NL-15-0074

Joseph M. Farley Nuclear Plant
Completion of Required Action by NRC Order EA-12-051
Reliable Spent Fuel Pool Level Instrumentation

NRC Requests for Information

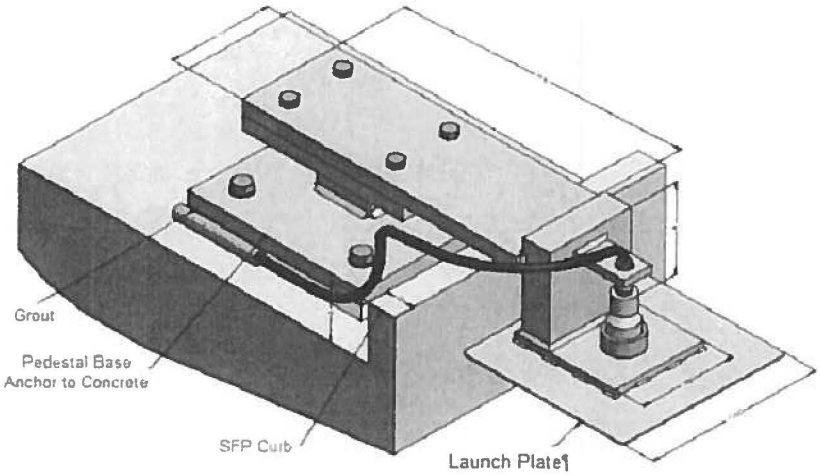
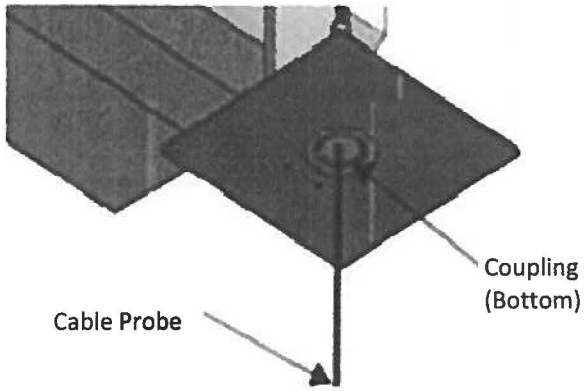
b) A description of the manner in which the level sensor (and stilling well, if appropriate) will be attached to the refueling floor and/or other support structures for each planned point of attachment of the probe assembly. Indicate in a schematic the portions of the level sensor that will serve as points of attachment for mechanical/mounting or electrical connections.

b) The mounting bracket is attached to the SFP concrete floor utilizing expansion-type concrete anchor bolts. The level sensor consists of a stranded stainless steel cable level probe that is threaded on the top end. The probe attaches (threads) into a coupling that is secured to the mounting bracket launch plate and extends down into the pool. The attachment to the signal cable is via a coaxial connection on the top side of the launch plate coupling.

The simplified drawing below shows a representation of the attachment of the probe and the sensor cable to the mounting bracket (launch plate), and mounting bracket attachment to the SFP structure. The Farley SFP does not have a raised concrete curb and as such, the mounting bracket does not utilize the curb for support.

Figure 1

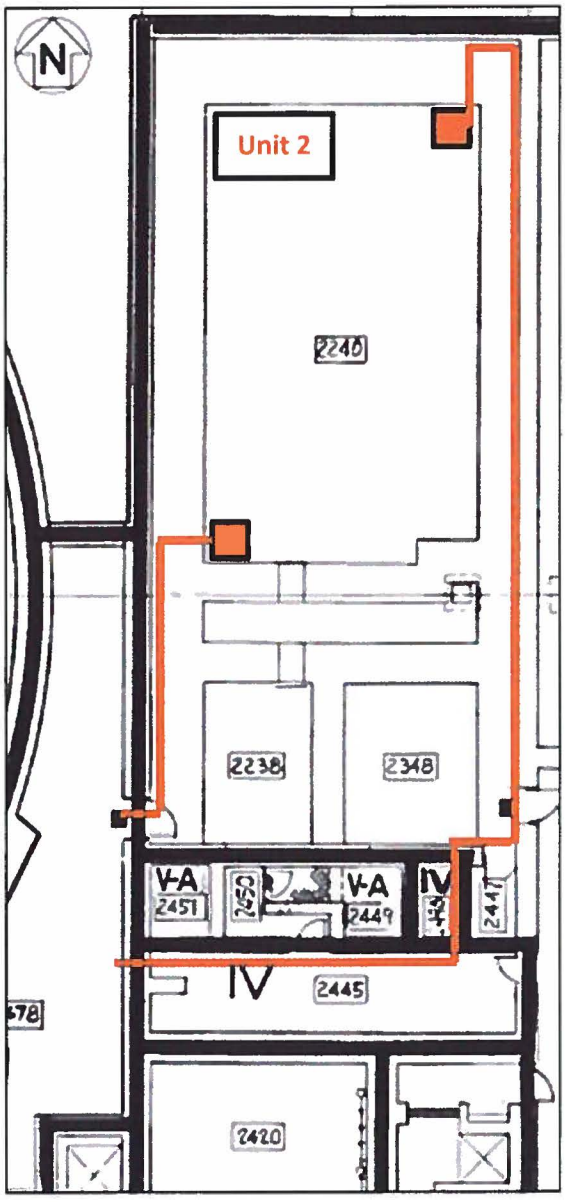
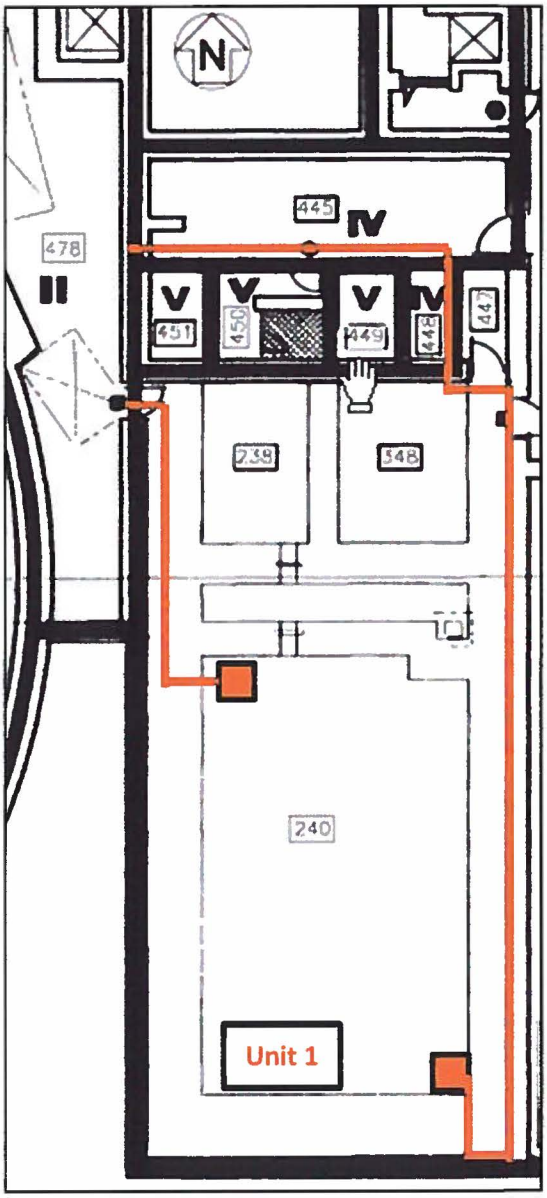
Please provide a clearly labeled sketch or marked-up plant drawing of the plan view of the SFP area, depicting the SFP inside dimensions, the planned locations/placement of the primary and back-up SFP level sensor, and the proposed routing of the cables that will extend from these sensors toward the location of the read-out/display device.

A plan view sketch of the SFP area is provided as Figure 1. The sketch depicts the SFP inside dimensions, locations/placement of the primary and alternate level sensors, and the routing of cables that extend toward the location of the electronics. Physical separation of the primary and alternate channels, to the extent practicable and comparable to the short side of the pool, is used to provide reasonable protection of the level indication function against missiles that may result from the damage to the structure over the SFP.

Figure 2

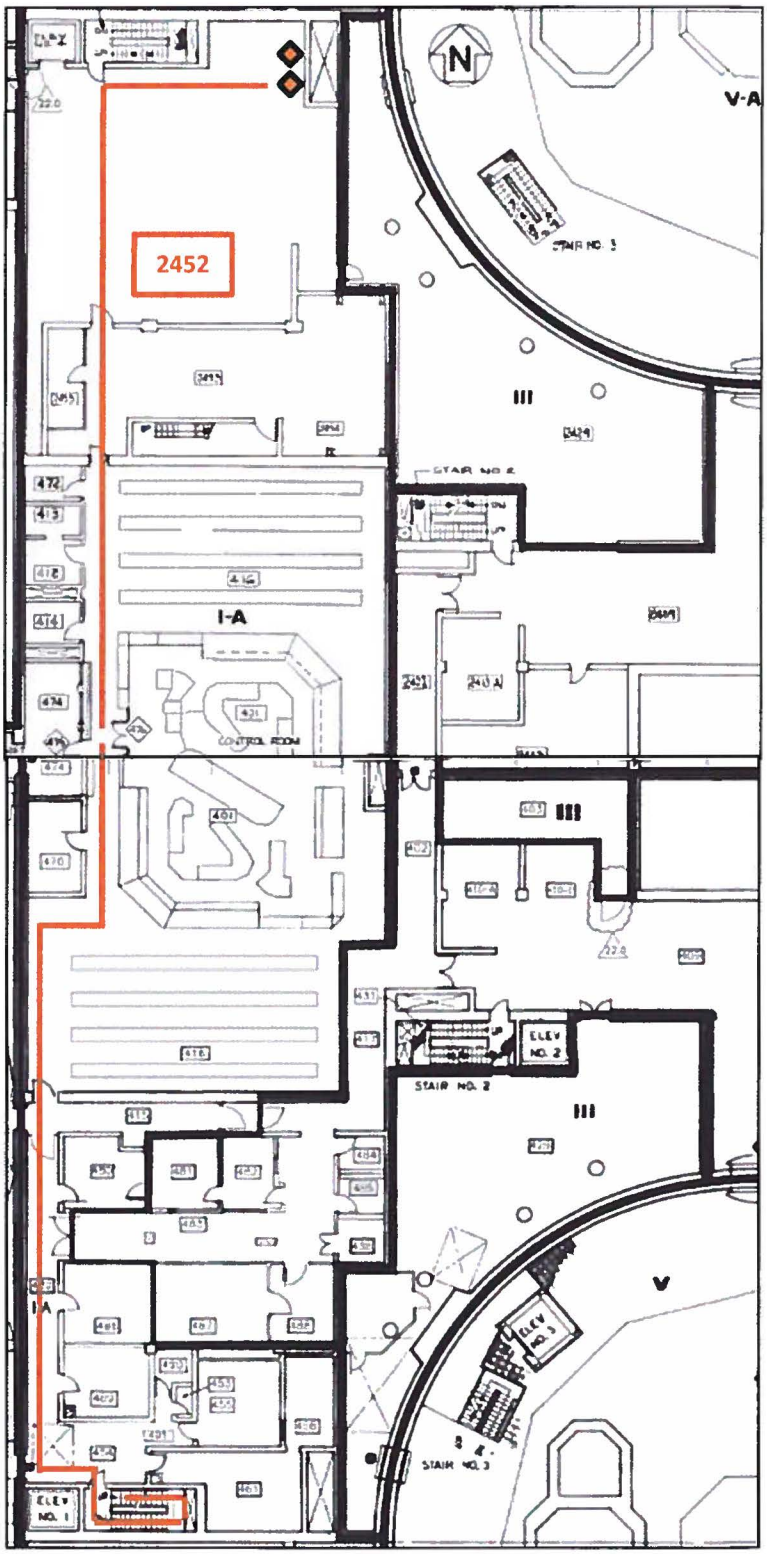
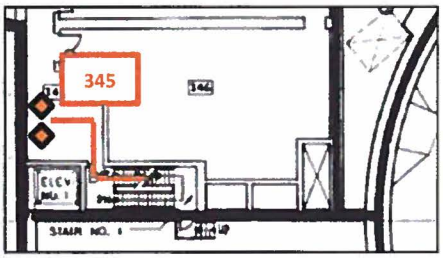
a) The specific location for the primary and backup instrument channel displays.

b) For any SFP level instrumentation displays located outside the main control room, please describe the evaluation used to validate that the display location can be accessed without unreasonable delay following a BDB event. Include the time available for personnel to access the display as credited in the evaluation, as well as the actual time (e.g., based on walk-throughs) that it will take for personnel to access the display. Additionally, please include a description of the radiological and environmental conditions on the paths personnel might take. Describe whether the display location remains habitable for radiological, heat and humidity, and other environmental conditions following a BDB event. Describe whether personnel are continuously stationed at the display or monitor the display periodically.

a) See Figure 2 for SFPLIS equipment location sketches.

The location of the U1 and U2 Primary display panels is room 2452 on EL 155' of the Aux Building. The location of the U1 and U2 Alternate display panels is room 345 on EL 139' of the Aux Building.

The selected location of the U1 and U2 Primary display panels in room 2452 on EL 155' of the Aux Building is approximately 180 feet from the West exit of the Control Room. The selected location of the U1 and U2 Alternate display panels in room 345 on EL 139' of the Aux Building is approximately 220 feet from the West exit of the Control Roo m. Using a conservative walking pace of 1 mph, Primary & Alternate display locations would each require less than 10 minutes to access the display location, perform local function and return to the Control Room. With the displays located outside the Radiation Controlled Area, the substantial structures between the SFP and the pathway to the display, combined with the short transient duration, personnel traveling the pathways

shown on Figure 2 will not require heroic means with the SFP at Level 3 or above. The display location remains habitable considering the: (1) minimal time required to periodically access the displays, (2) distance from the SFP and substantial structures, and (3) the lack of heat producing equipment within the room during accident conditions. Accordingly, both the Primary and Alternate SFPLI panel locations allow prompt, non-heroic access to the displays from the Control Room necessary to allow periodic monitoring of the SFP level.
